PRODUCT BULLETIN

PB NO. 102
rev. 1

Subject: **Camshaft Lobe Wear**
Superior 510 & 825 (Inline-Vee) Series Engines

PROBLEM Premature Camshaft Lobe Wear Caused by
Inadequate Pin to Roller Lubrication

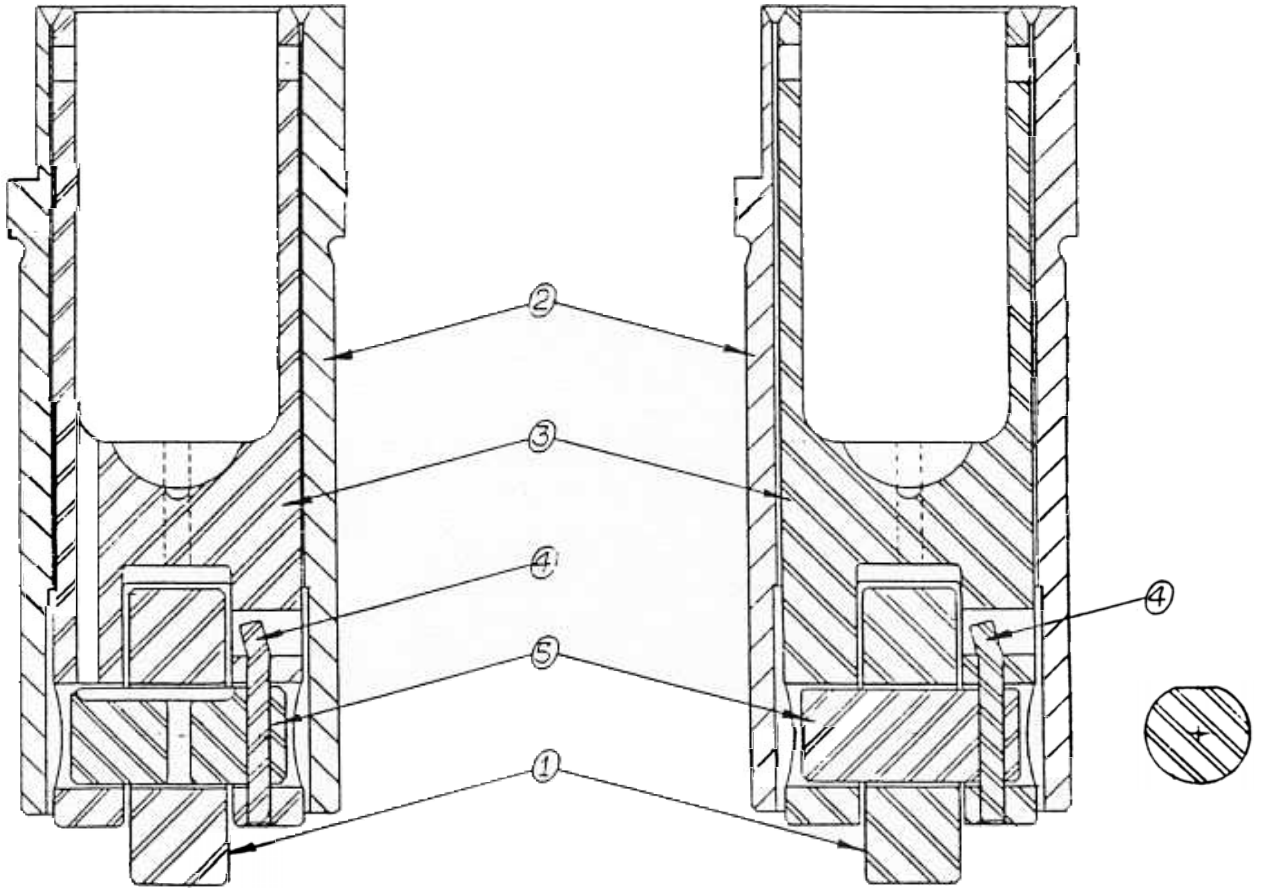
4. The new **PowerParts**[®] design prelubes the roller-pin area by filling the pin top groove and through hole to the load side of the pin.
5. All standard available designs showed roller to pin galling after as low as 1-1/2 hours of operation in splash environment. No roller to pin galling was present in the new **PowerParts**[®] design in one (1) week continuous run with zero splash lubrication.

CAM FOLLOWER ASSEMBLY
-FOR MODEL 825 SUPERIOR ENGINES-

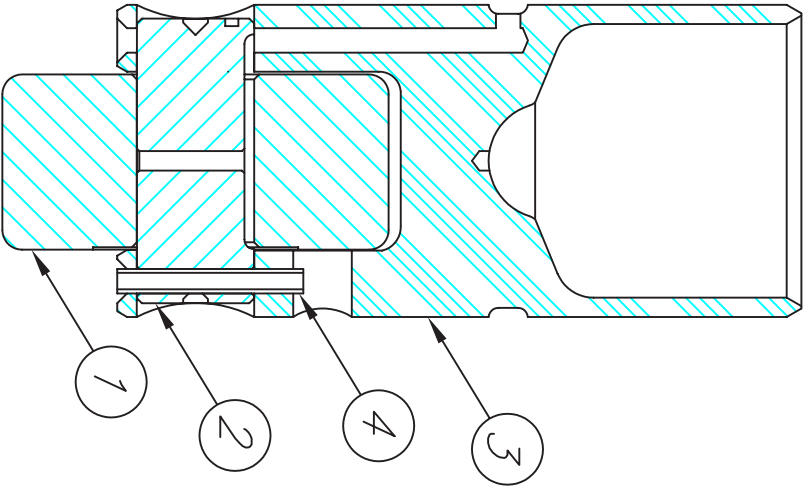
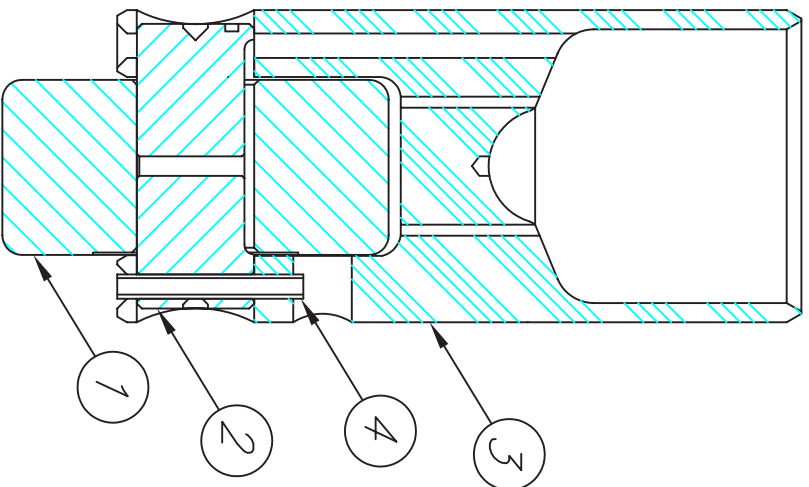
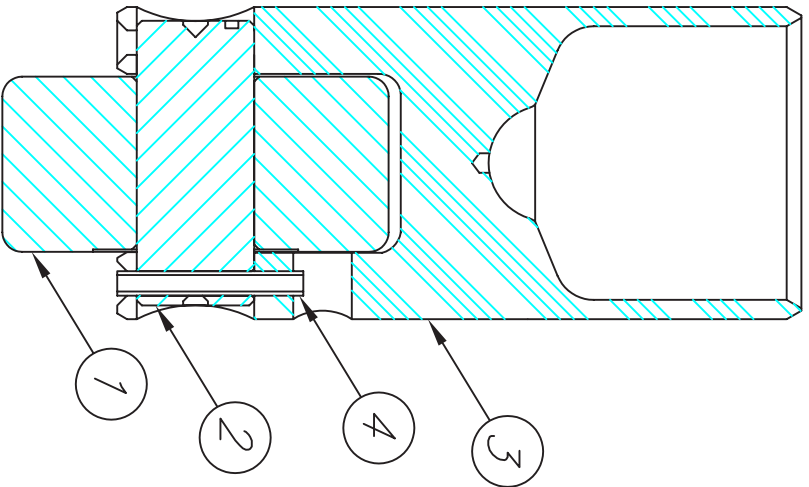
III. Solution: The solution to the above problems a new **PowerParts**[®] cam follower assembly with the state of the art materials and a design which increases the roller to pin lubrication over 10 times. The attached cross sections, compares the OEM and **PowerParts**[®] assemblies and indicates the design changes which result in proper pin to roller lubrication.
